NM NIAGARA NINE MILE POINT MOHAWK NUCLEAR STATION

EDC NO	2	E	1	0	1	3	0	REV
--------	---	---	---	---	---	---	---	-----

8/88
 NEL-050
 ENGINEERING DESIGN CHANGE

LABELING CHANGES AND DRAWING CHANGES TO CLARIFY LABELS ON Uninterruptible Power Supplies FOR CLARIFICATION AND CONSISTANCY. AND TO REFLECT AS BUILT CONDITIONS.

SWEGNO: 1.560-229-004

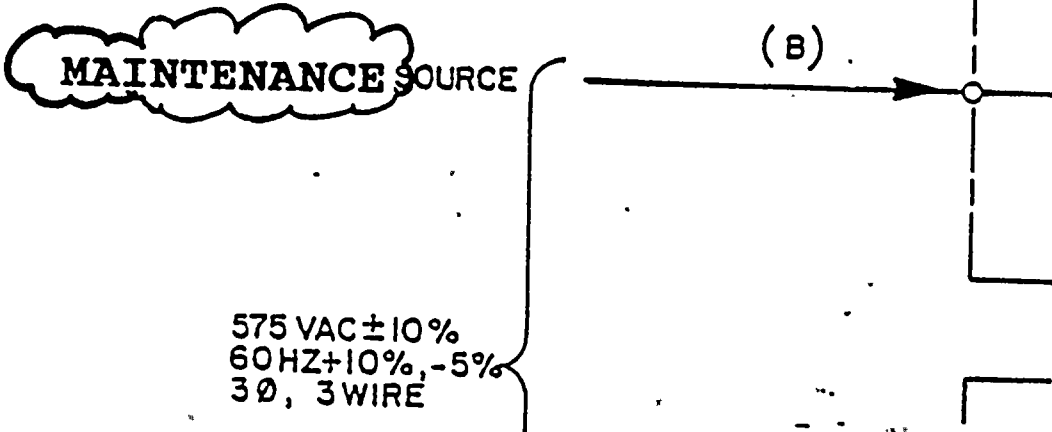
FROM:

TO:

SWECNO 1.560-229-005

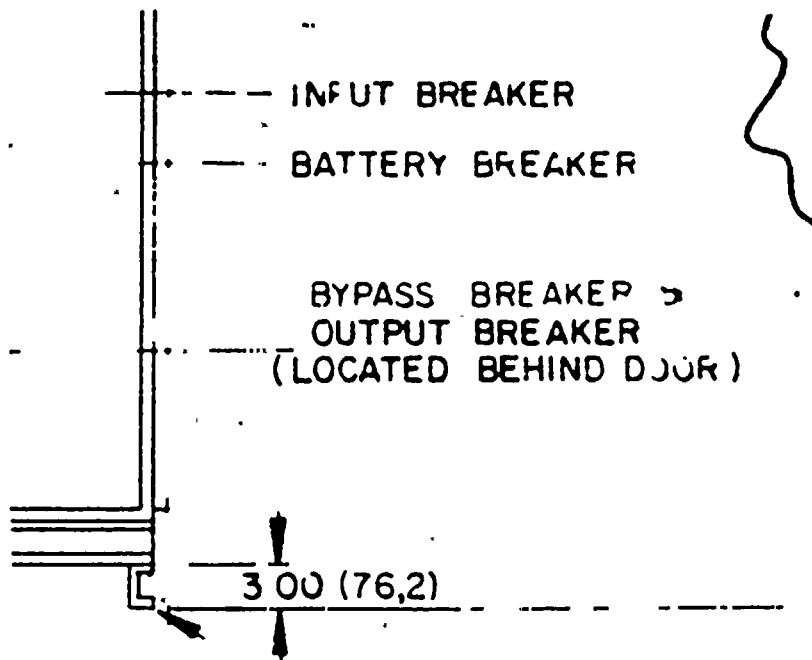
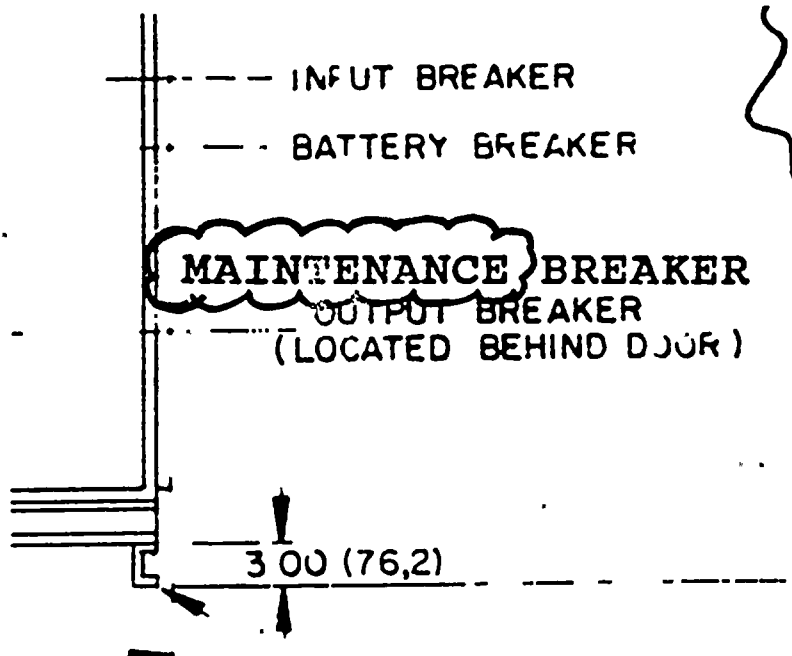
FROM:

TO:

SWECNO 1.560-229-007

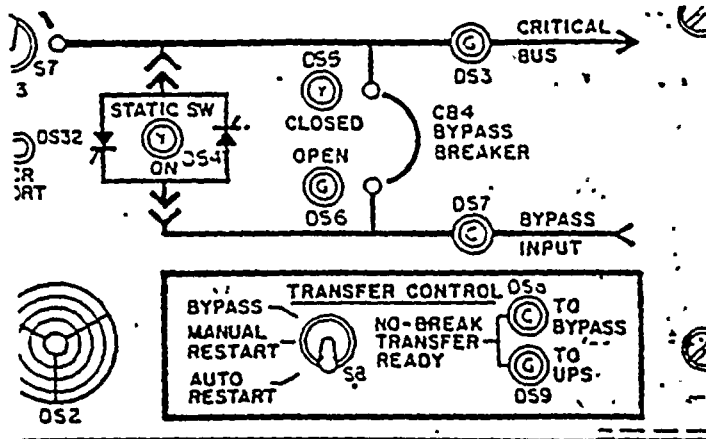
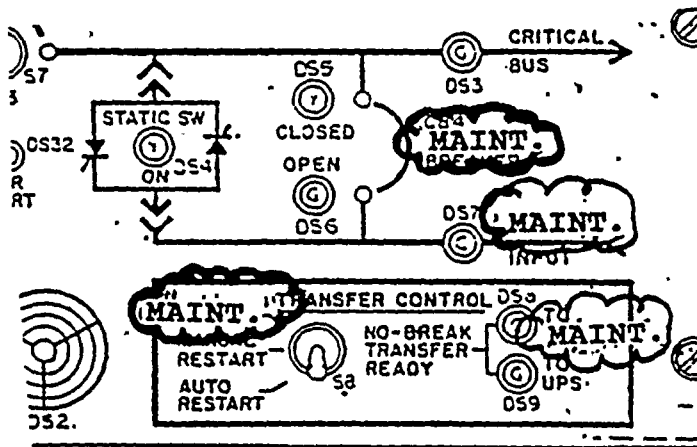
FROM:

TO:

SWECNO: 1.560-229-013

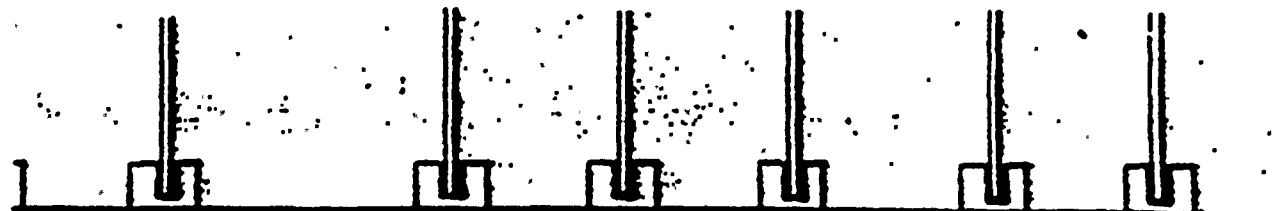
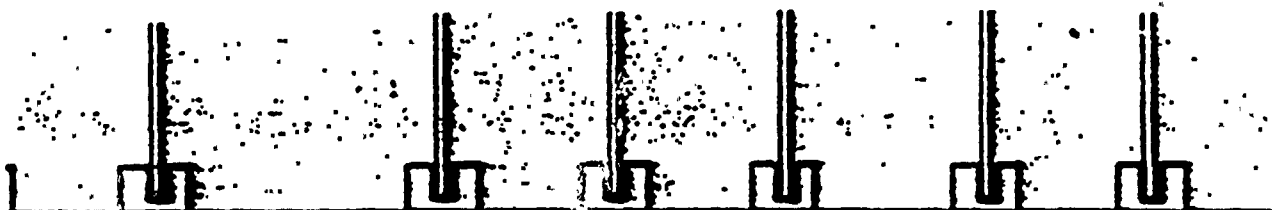
FROM:

A3 A5 A8 A9 A12 A18

OVERLOAD TRANSFER
 UV/OV TRANSFER
 TRANSFER LOCKOUT
 BYPASS OUT OF LIMITS
 VOLTAGE DIFFERENCE
 OUTPUT OV/UV
 STATIC SWITCH UNPLUGGED

TO:

OVERLOAD TRANSFER
 UV/OV TRANSFER
 TRANSFER LOCKOUT
 MAINTENANCE OUT OF LIMITS
 VOLTAGE DIFFERENCE
 OUTPUT OV/UV
 STATIC SWITCH UNPLUGGED

SWECNO: 1.560-229-013

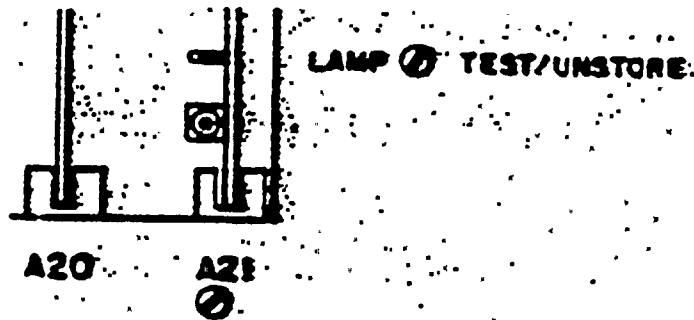
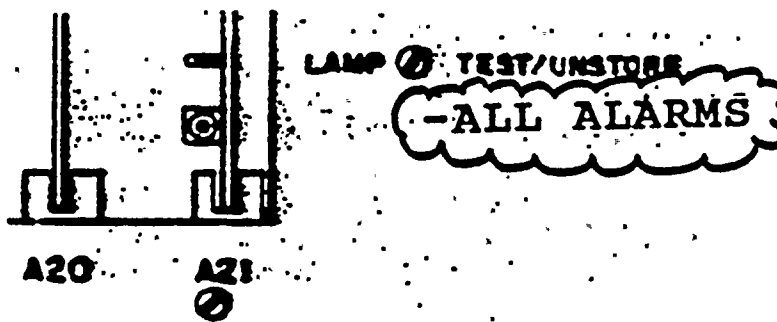
FROM:

TO:

SWECNO: 1.560-229-017

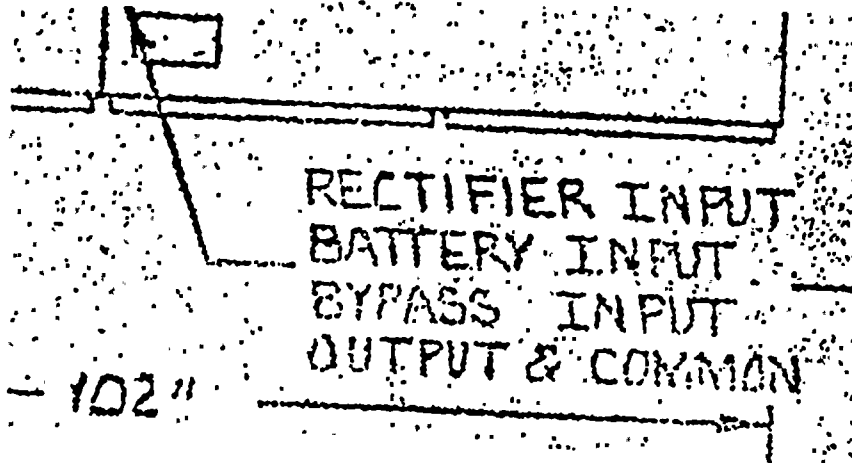
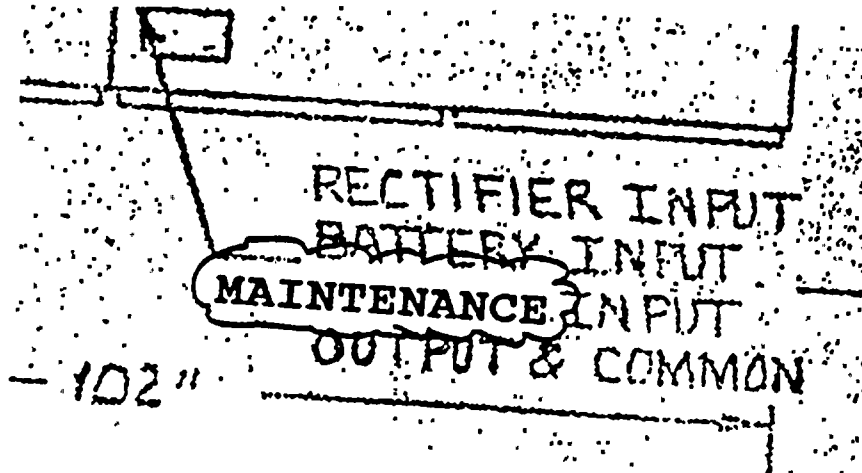
FROM:

TO:

SWENB: 1560-229-017
FROM:

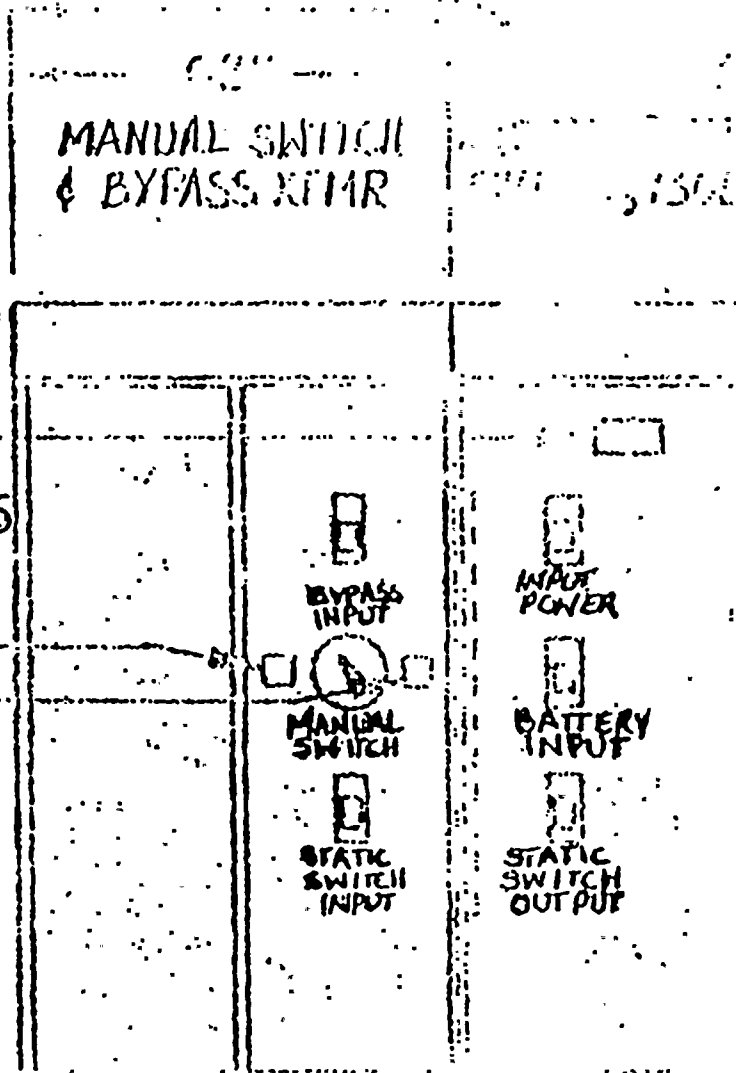
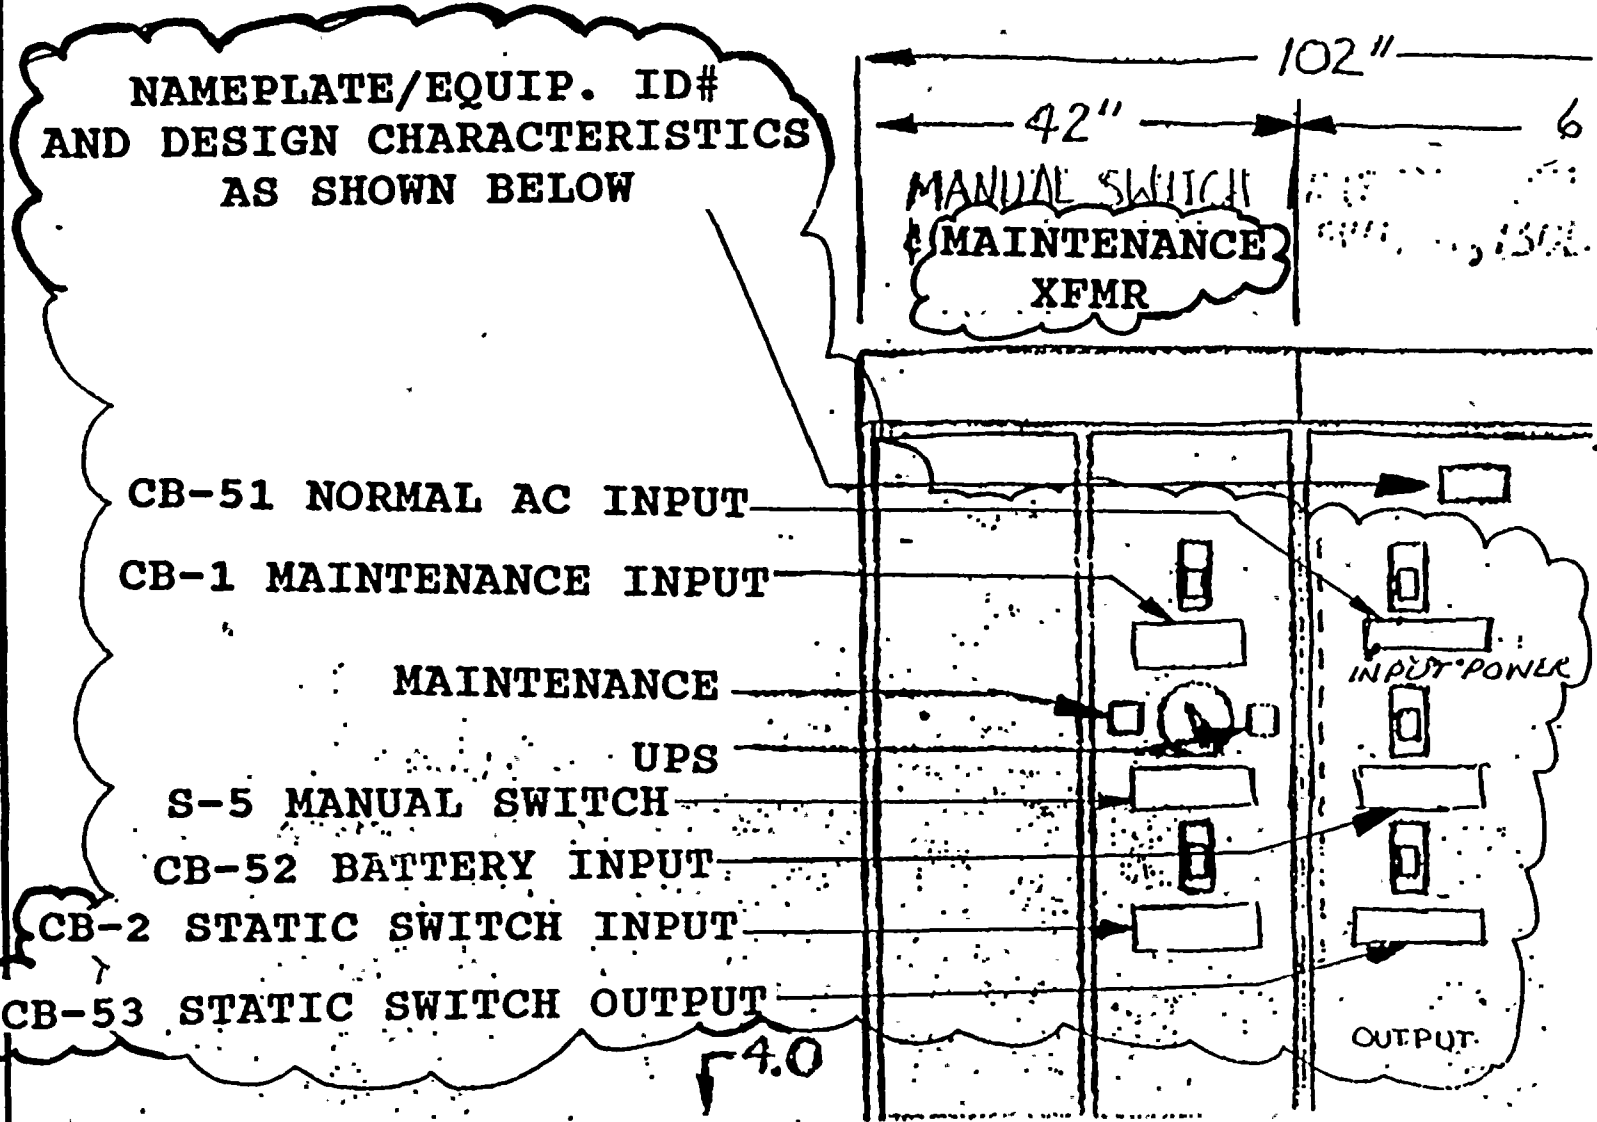
MANUAL SWITCH
& BYPASS KEYS

BYPASS
UPS

NAMEPLATE/EQUIP. ID# AND DESIGN CHARACTERISTICS AS SHOWN BELOW

CB-51 NORMAL AC INPUT

CB-1 MAINTENANCE INPUT

S-5 MANUAL SWITCH

MANUAL SWITCH (MAINTENANCE) XFMR

SWECD NO: 1.520-229-018
FROM:

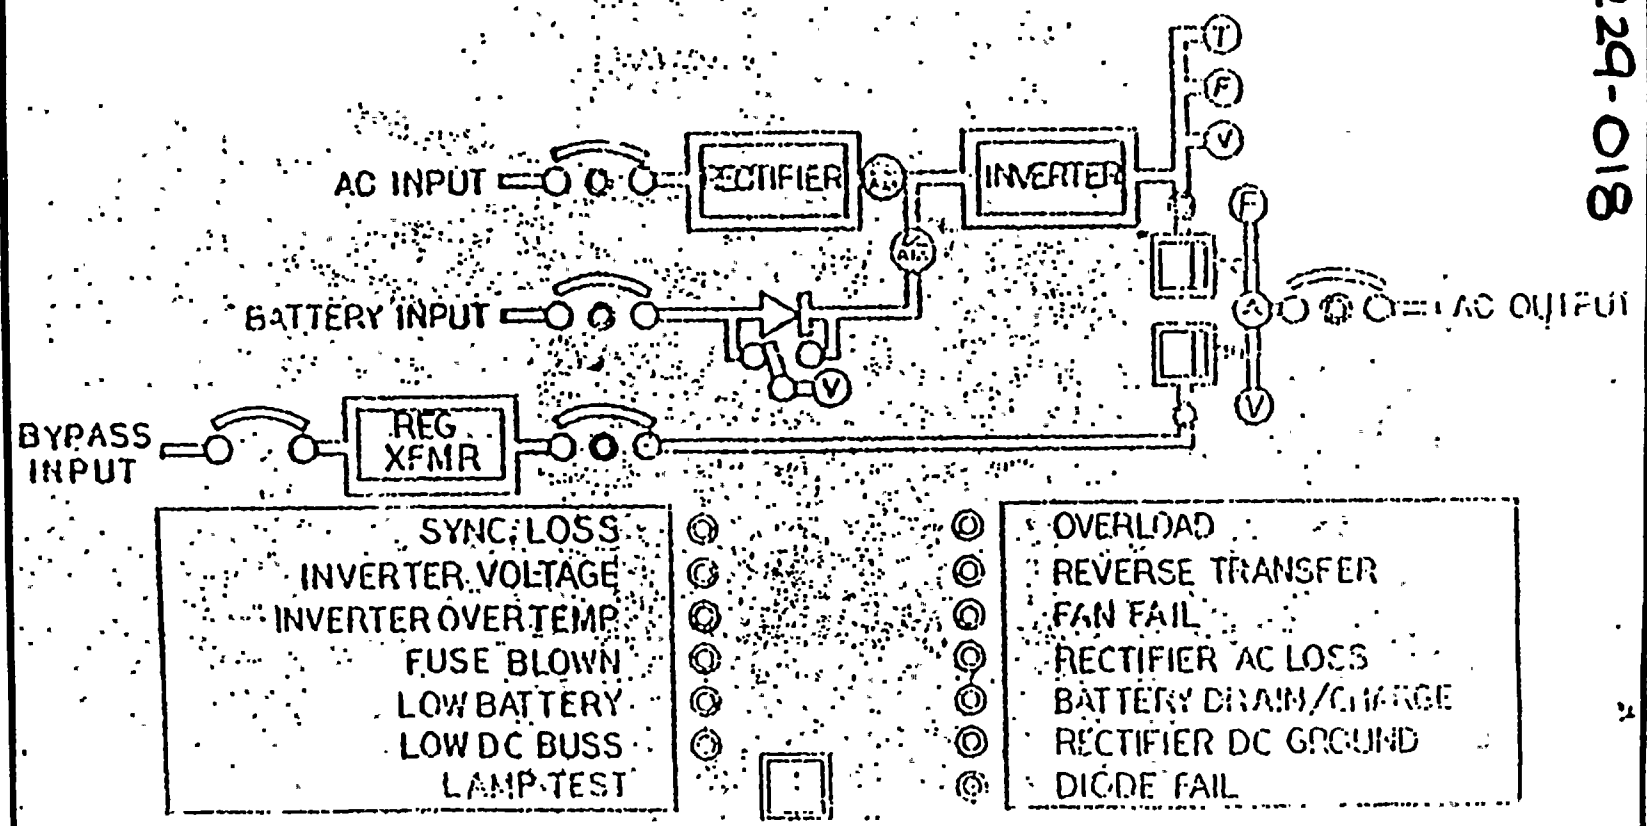
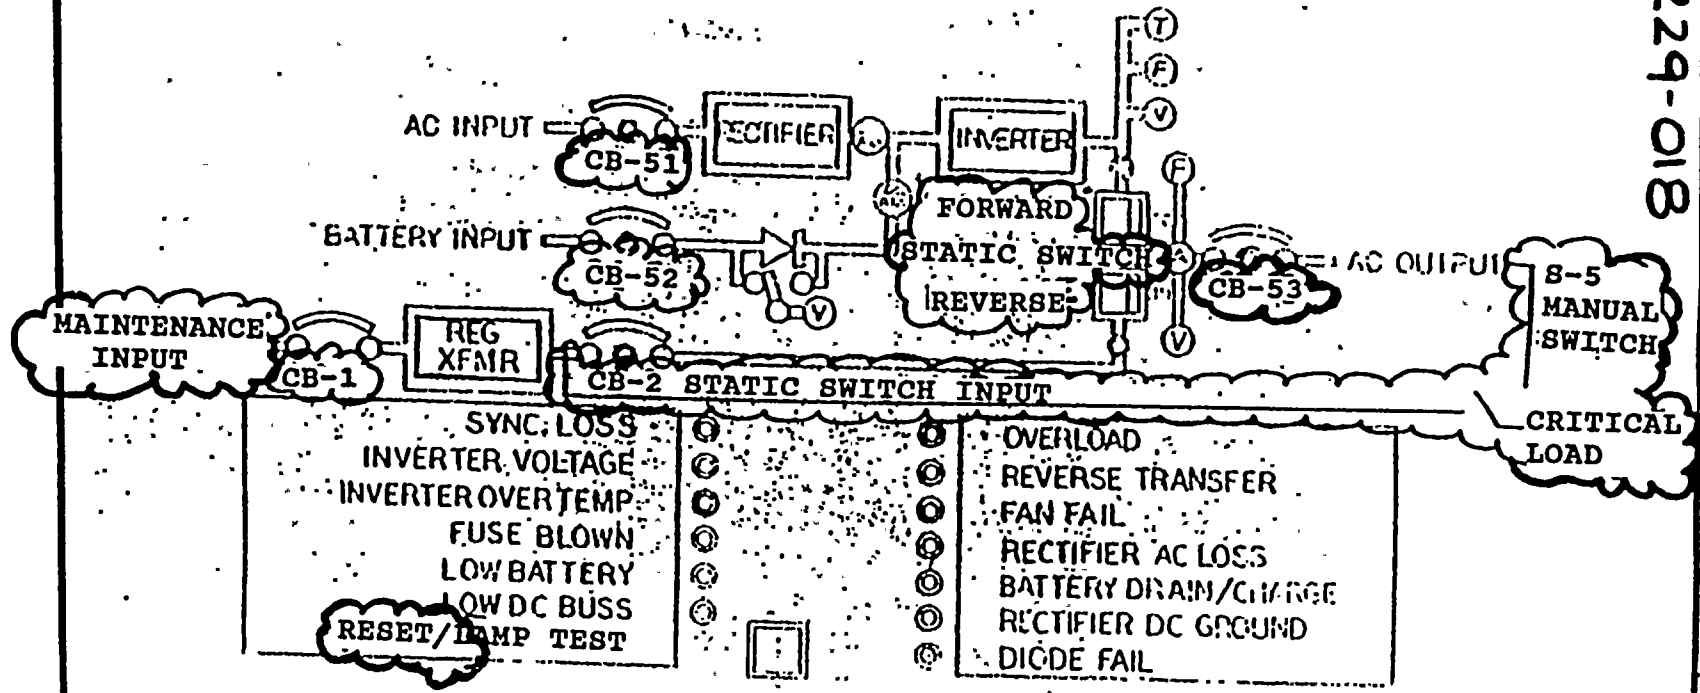
- SYNC LOSS
- INVERTER VOLTAGE
- INVERTER OVERTEMP
- FUSE BLOWN
- LOW BATTERY
- LOW DC BUSS
- LAMP TEST

- OVERLOAD
- REVERSE TRANSFER
- FAN FAIL
- RECTIFIER AC LOSS
- BATTERY DRAIN/CHARGE
- RECTIFIER DC GROUND
- DIODE FAIL

SWECNO: 1.560-229-019 AREA C4.

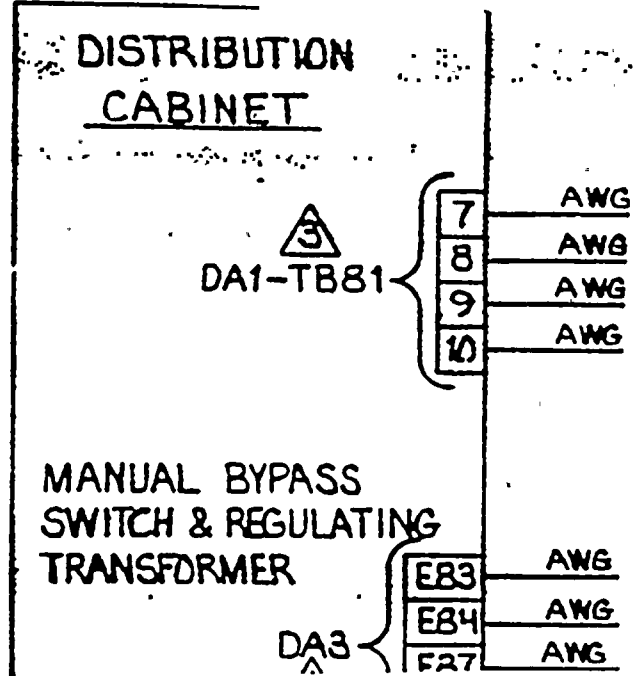
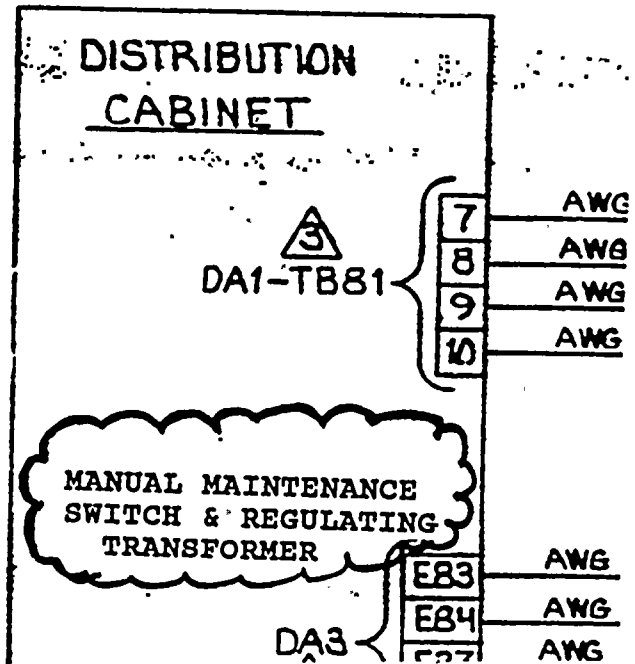
FROM:

TO:

SWECNO: 1.560-229-019

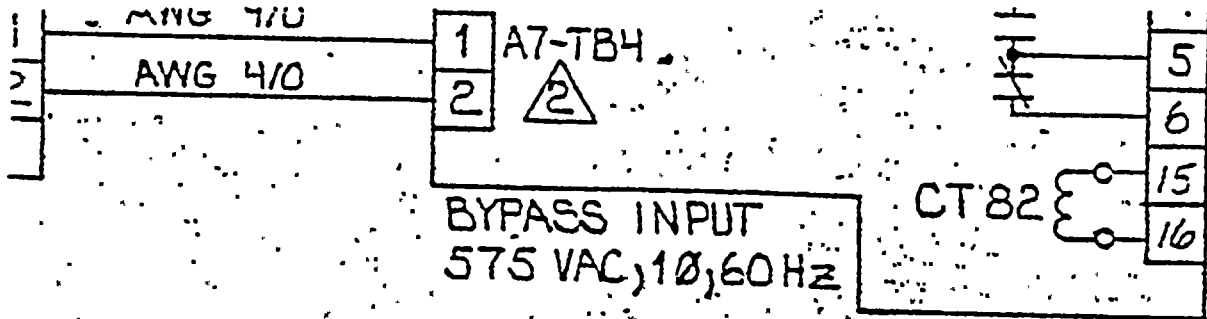
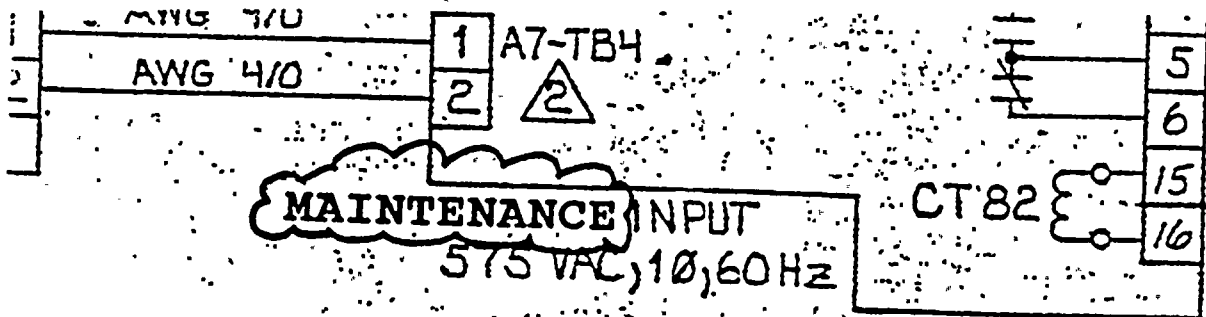
FROM:

DETAIL "A"

TO:

DETAIL "A"
